ENGINE - LP COMPRESSOR - LPC BLEED VALVE LINKAGE SYSTEM WITH IMPROVED DURABILITY -
CATEGORY CODE 8 - MOD.ENG-72-0133

V2500-ENG-72-0133

LPC Bleed Valve Linkage System - Before and After Alteration
Fig.1

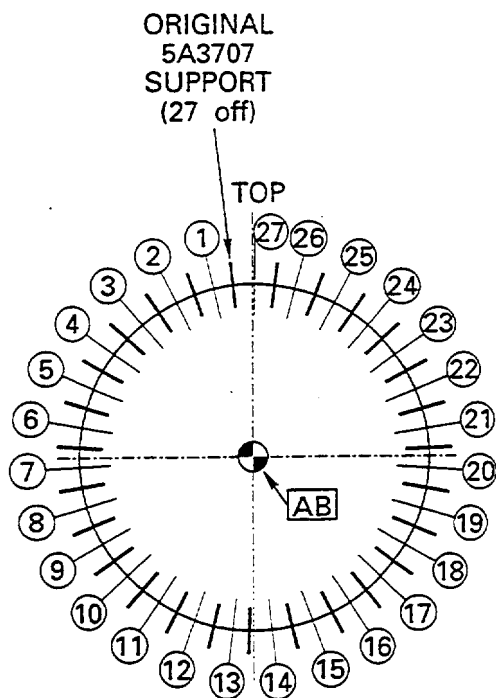
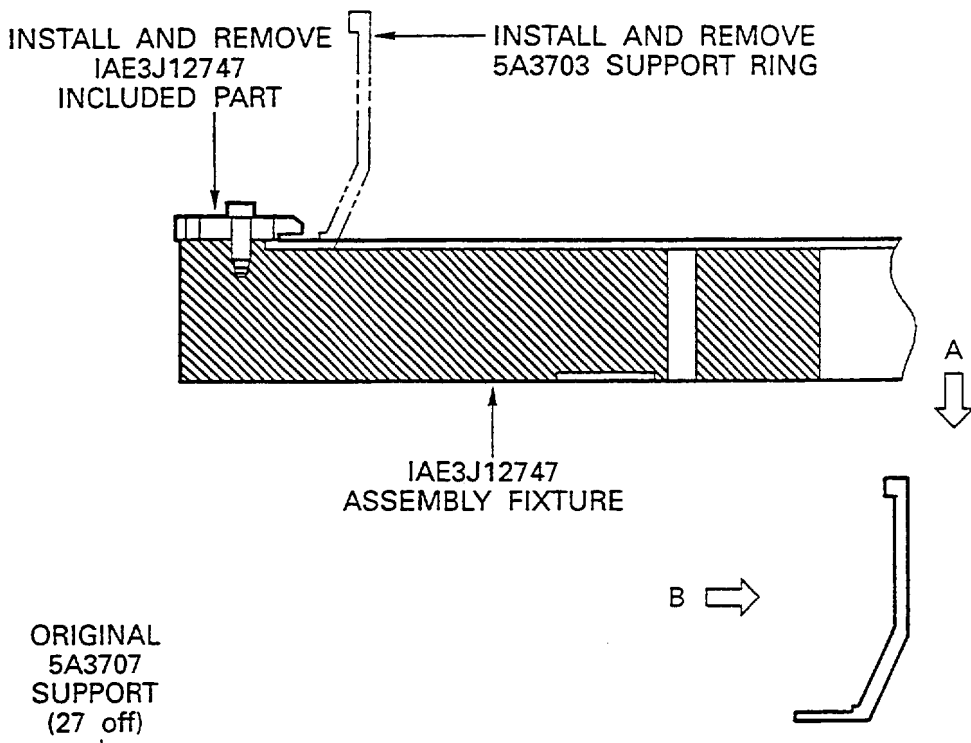
- (1) The changes introduced by this Service Bulletin are as follows;
- (a) Additional mid-supports are fabricated in around the Support Ring A/0 to increase the stiffness of the Bleed Valve Mechanism. (See Figure 1)
 - (b) Pins and Nuts which connect the Bleed Valve to the Link Arm have been changed to improve linkage system durability. (See Figure 4 Sheet 2)
 - (c) Additional bushes are fitted on the Synchronize Ring. (See Figure 4 Sheet 6)
 - (d) The Synchronize Ring Guides and the Guide Pins have been changed to increase the diameter.
 - (e) The procedures for adjusting the Actuating Rods are changed.
- (2) Old Part Number 5A3703, Support Ring A/0 can be reworked to the new configuration. (See Figure 2, Sheet 1, 2, 3 and 4)
- (3) Old part number 5A3724, Synchronizing Ring can be reworked to the new configuration. (See Figure 3, Sheet 1, 2, 3 and 4)

Modification of Support Ring Assembly
Fig.2 (Sheet 1)

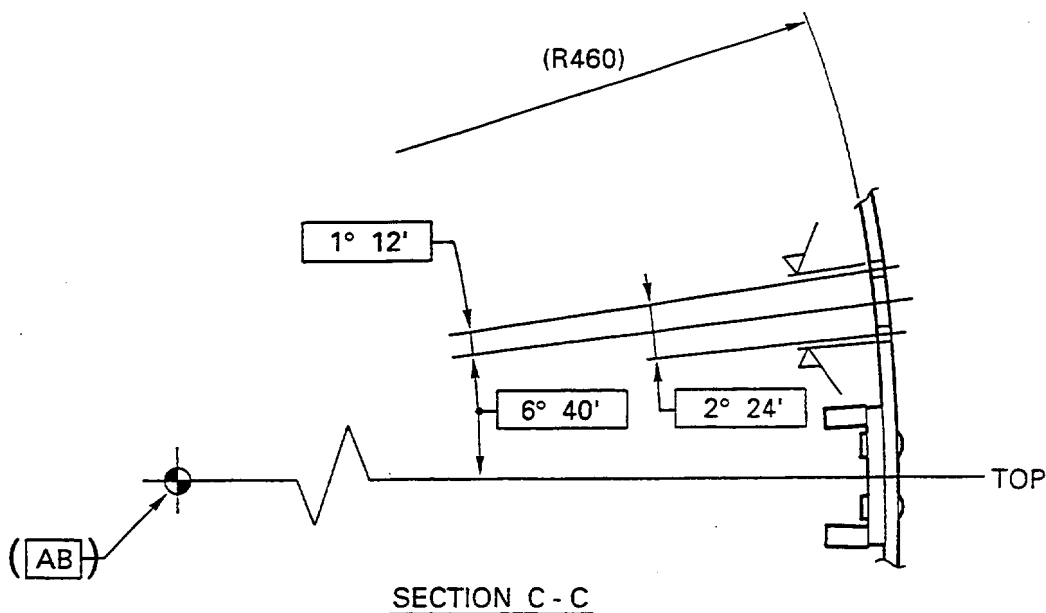
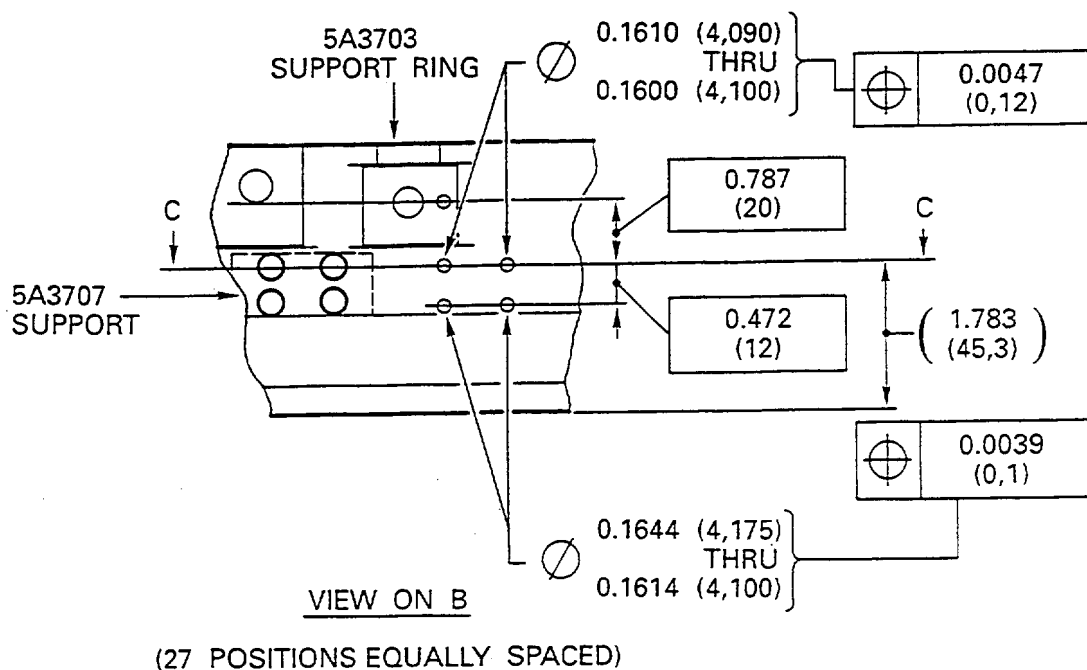
Procedure	Supplementary Information
(a) Set the Support Ring on to the Fixture.	Use IAE 3J12747 Assembly Fixture. Refer to Figure 2 (Sheet 1)
(b) Locate the Support Ring in the Fixture, Set up and secure to the face plate of the Horizontal Boring Mill.	Refer to Reference (4)

(c) Drill the hole for one position (four holes in each) and do modification at the 27 positions (108 holes total).	Refer to Figure 2 (Sheet 1 and 2)
(d) Remove the Support Ring from the Horizontal Boring Mill and the Fixture.

Modification of Support Ring Assembly
Fig.2 (Sheet 2)

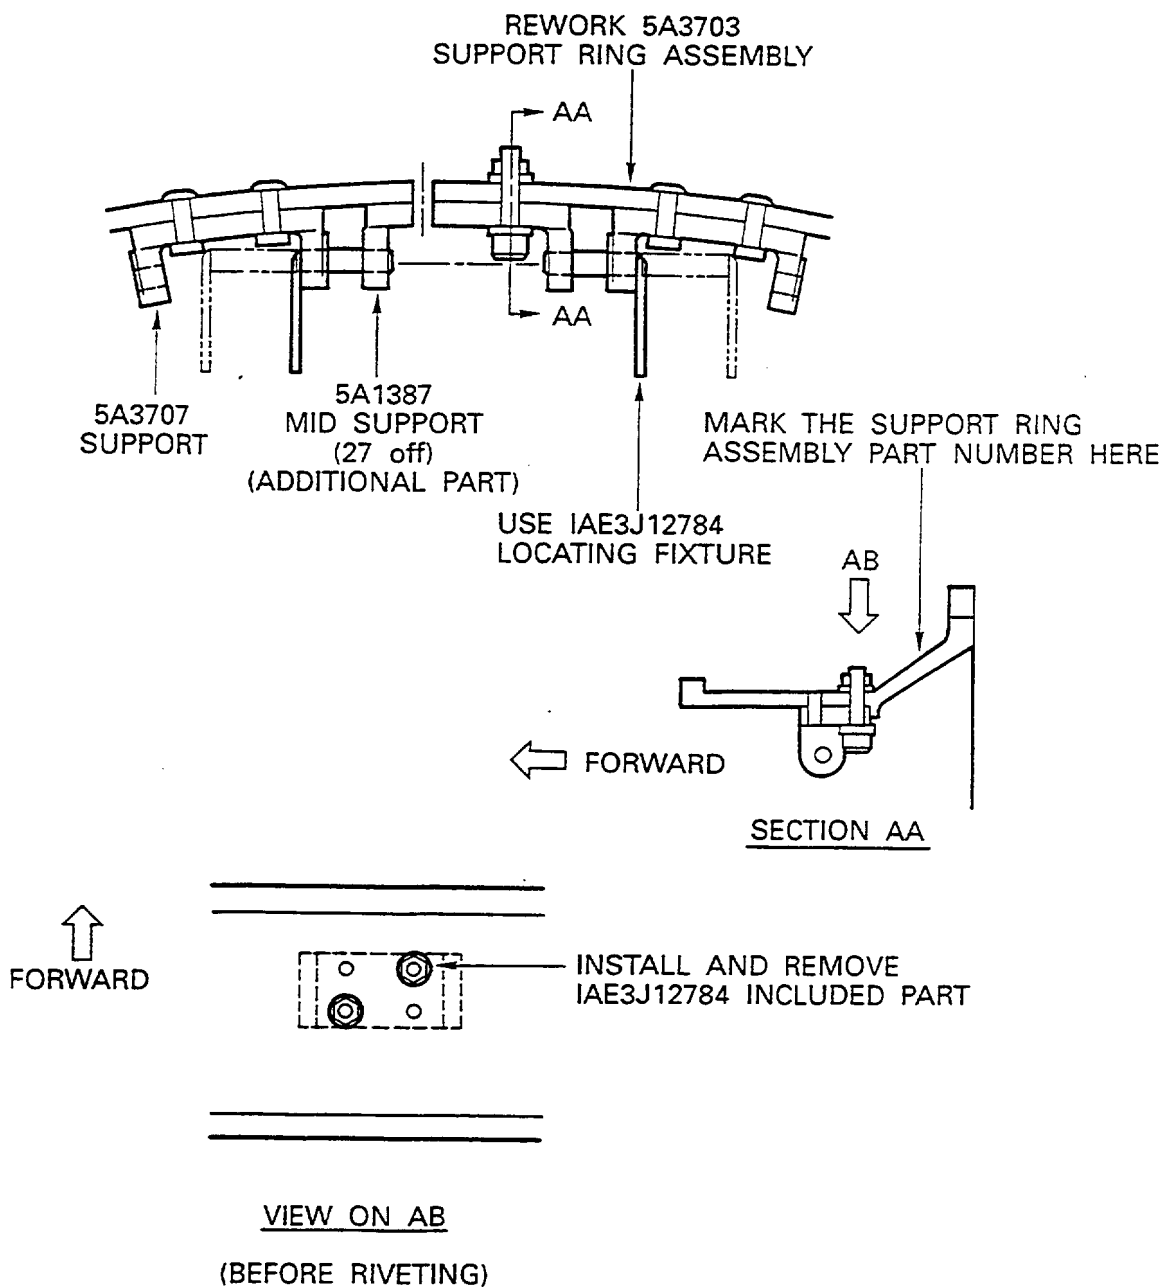
(e) Do an anodize touch up coating to all surfaces of 108 holes Use the brushing method.	Refer to Reference (3) Control No./TASK No. 70-38-02-300-503
(f) Visually and dimensionally examine each hole on the Support Ring.	Refer to Figure 2 (Sheet 1 and 2)

Modification of Support Ring Assembly
Fig.2 (Sheet 3)

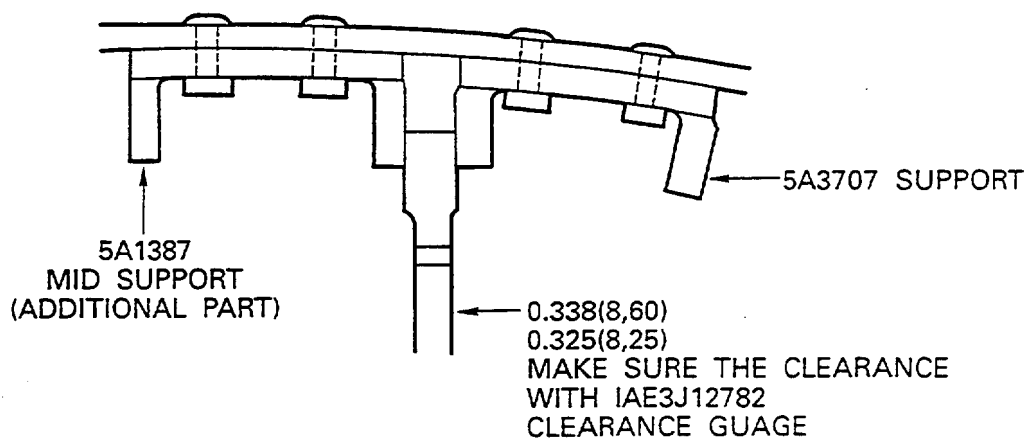
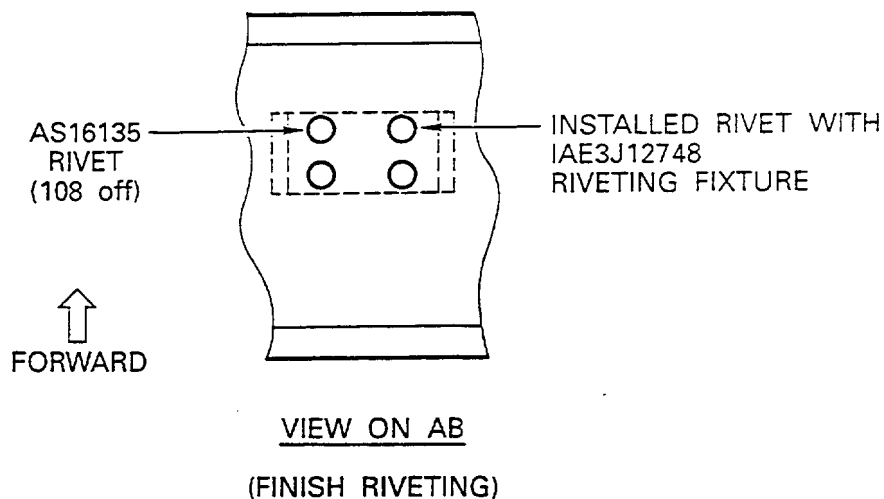
(g) Put the 27 new Mid Support in around the Support Ring and then use the Fixture through the pin hole of both Support and Mid Support, The two bolts are installed through the Mid Support and Support Ring with washers and nuts temporarily into the two positions.	Use IAE 3J12784 Locating Fixture. Refer to Figure 2 (Sheet 3)

(h) Install the two AS16135, Rivets first in to the position through the Mid Support and Support Ring use the Fixture.	Use IAE 3J12748 Riveting Fixture. Refer to Figure 2 (Sheet 3) and Reference (3) Control No./TASK No. 70-39-00-390-501

Modification of Support Ring Assembly
Fig.2 (Sheet 4)

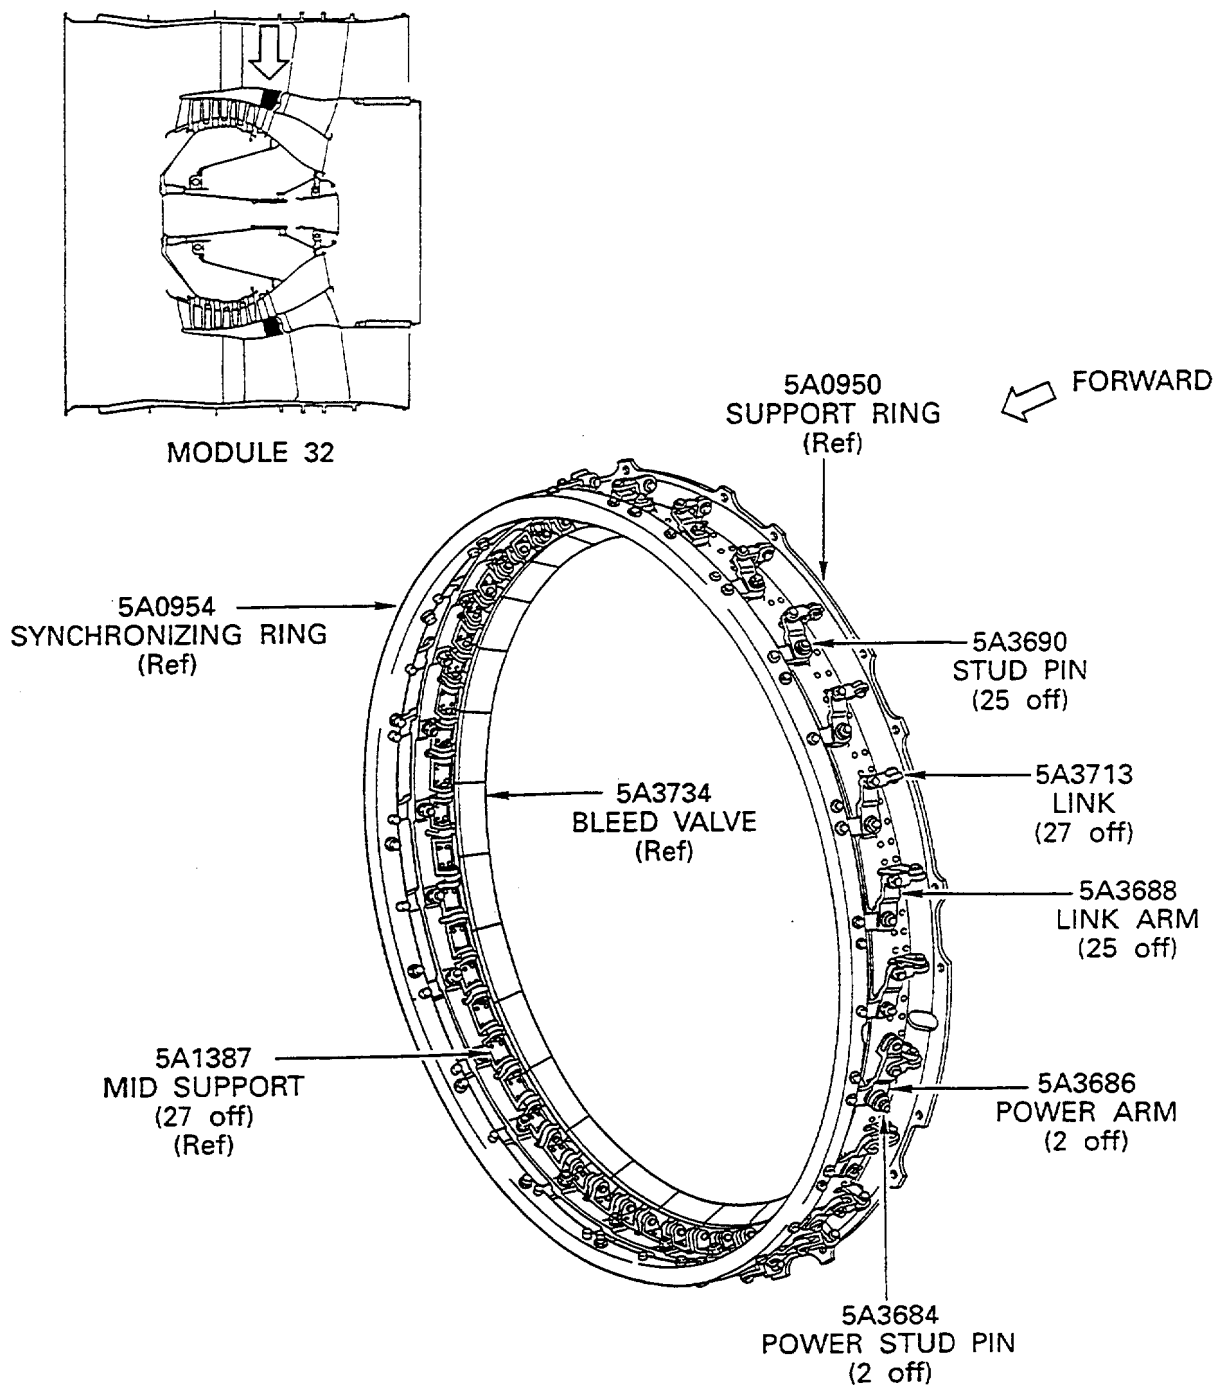
- (j) Do again same procedure for the other two rivets. Refer to Figure 2 (Sheet 3 and 4)
- (k) Do again step (a), (b), (c) and (d) for the other 26 positions. Refer to Figure 2 (Sheet 3 and 4)
- (l) Examine the clearances between new Mid Support and Support on the Support Ring Assembly for 54 positions. Use IAE 3J12782 Clearance Gauge
The formed rivet and rivet head must be tight and must have no crack or sign of bursting at the periphery. Refer to Figure 2 (Sheet 4)
- (m) Mark the re-number adjacent to the existing part number. Existing Renumber
5A3703 5A0950
Use the Vibration Peening Method. Refer to Figure 2 (Sheet 3) and Reference (3) Control No. /TASK No. 70-09-00-400-001
- (2) Do a modification on 5A3724, Synchronizing Ring and reidentify to the new part number 5A0954 as follows:

Hole Positions on the Synchronizing Ring
Fig.3 (Sheet 3)

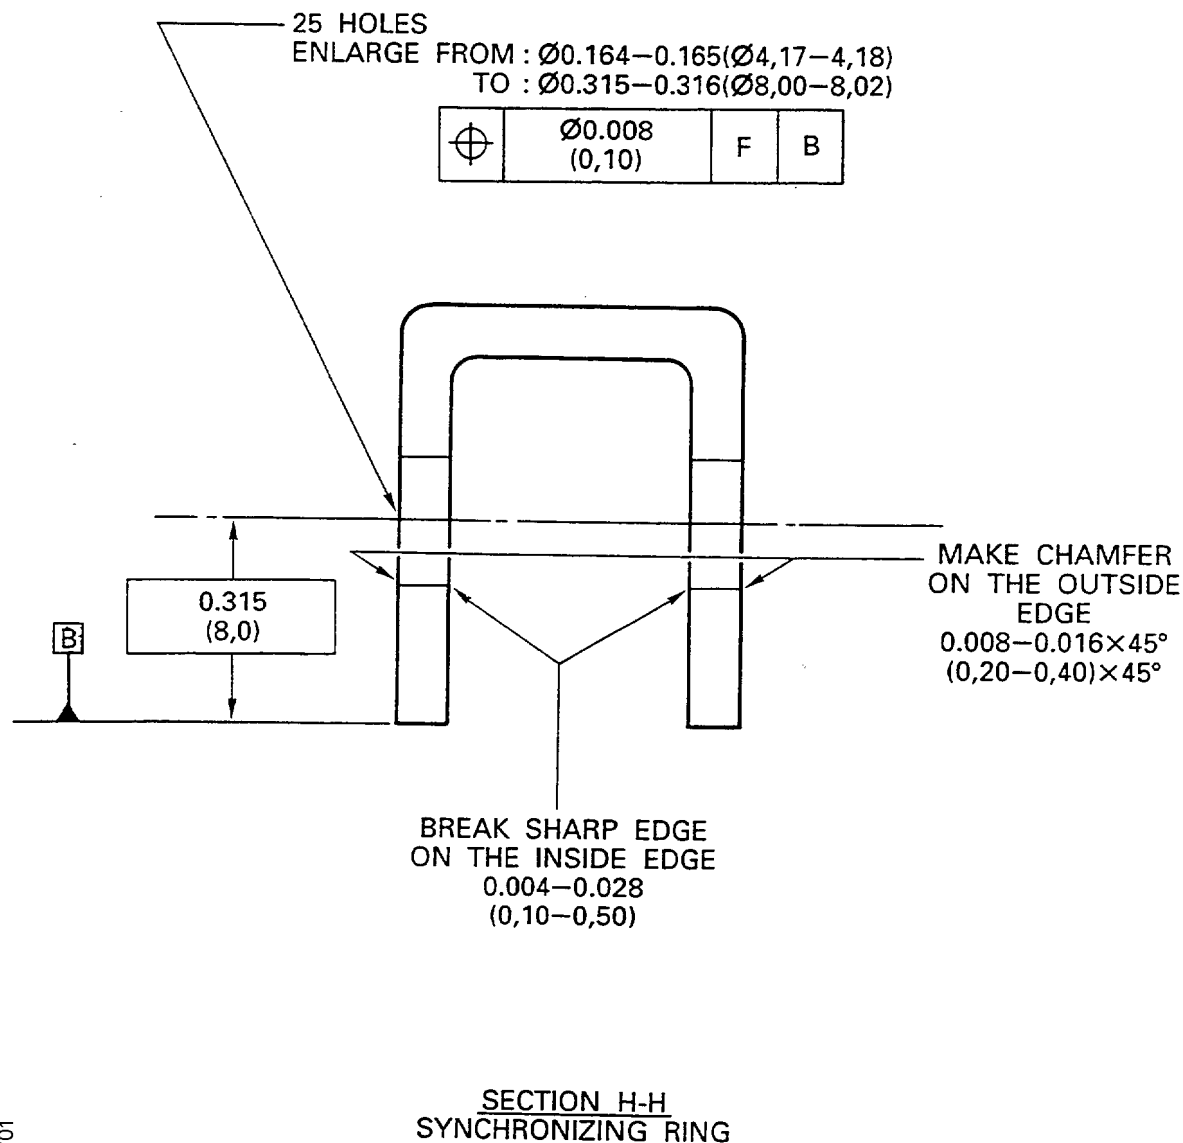
| (f) | Find a 'Top' marking and two scallops on the Synchronizing Ring, and adjust the zero degree of the Turn Table to the center of hole 'C'. | Refer to Figure 3

Enlarge 25 Holes on the Synchronizing Ring
Fig.3 (Sheet 4)

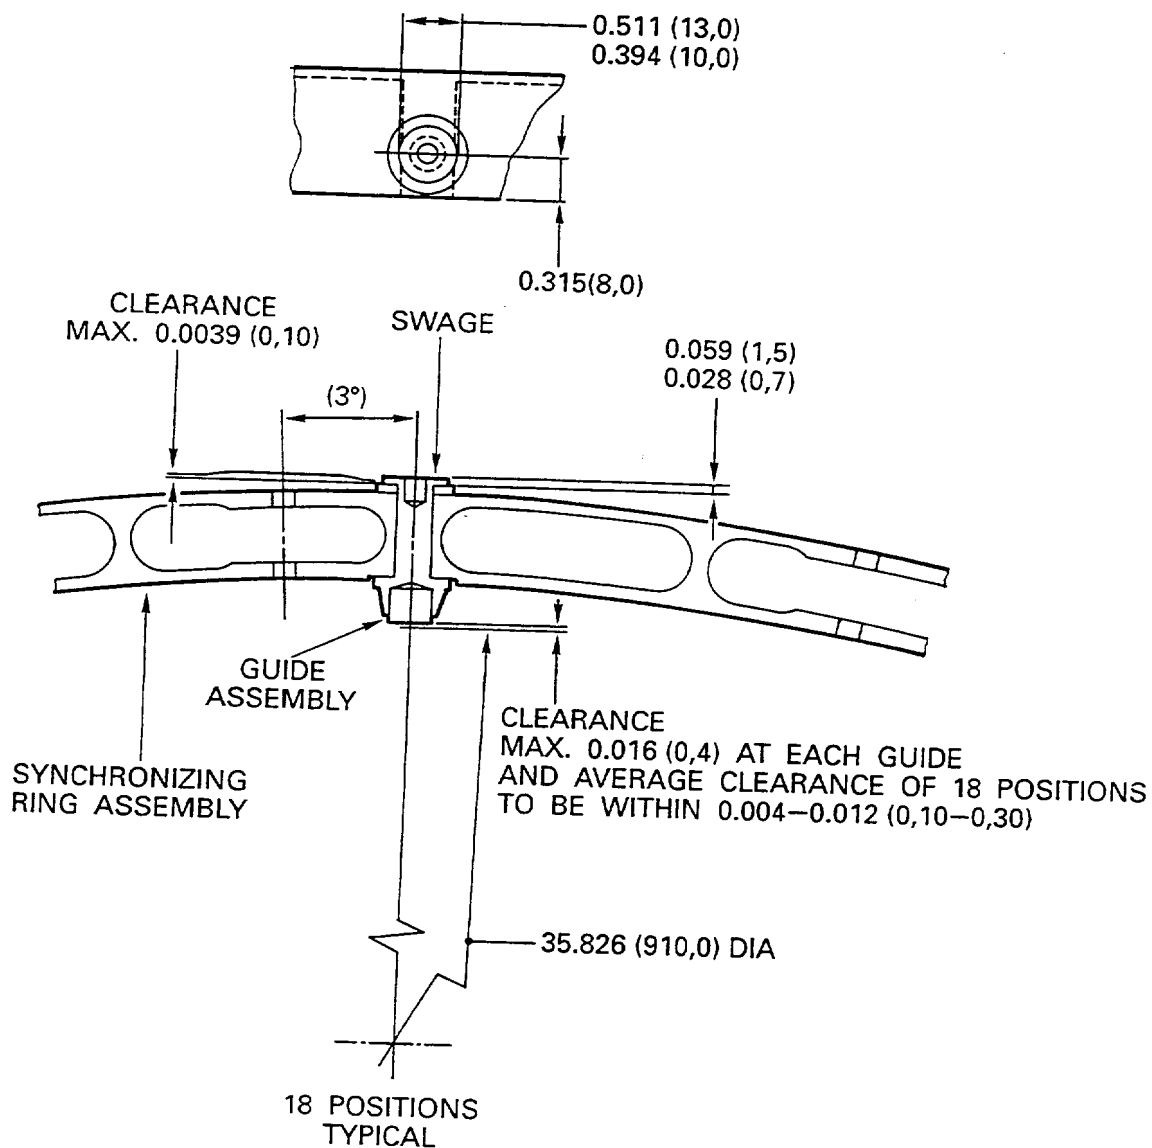
| (g) | Enlarge 25 holes on the Synchronizing Ring with a drill.

Make sure that the drill center aligns with each existing hole. | Refer to Figure 3
(Sheet 4). |

| (i) | Make chamfer on the outside edge of each hole. Break the sharp edge on the inside edge of each hole. | Refer to Figure 3
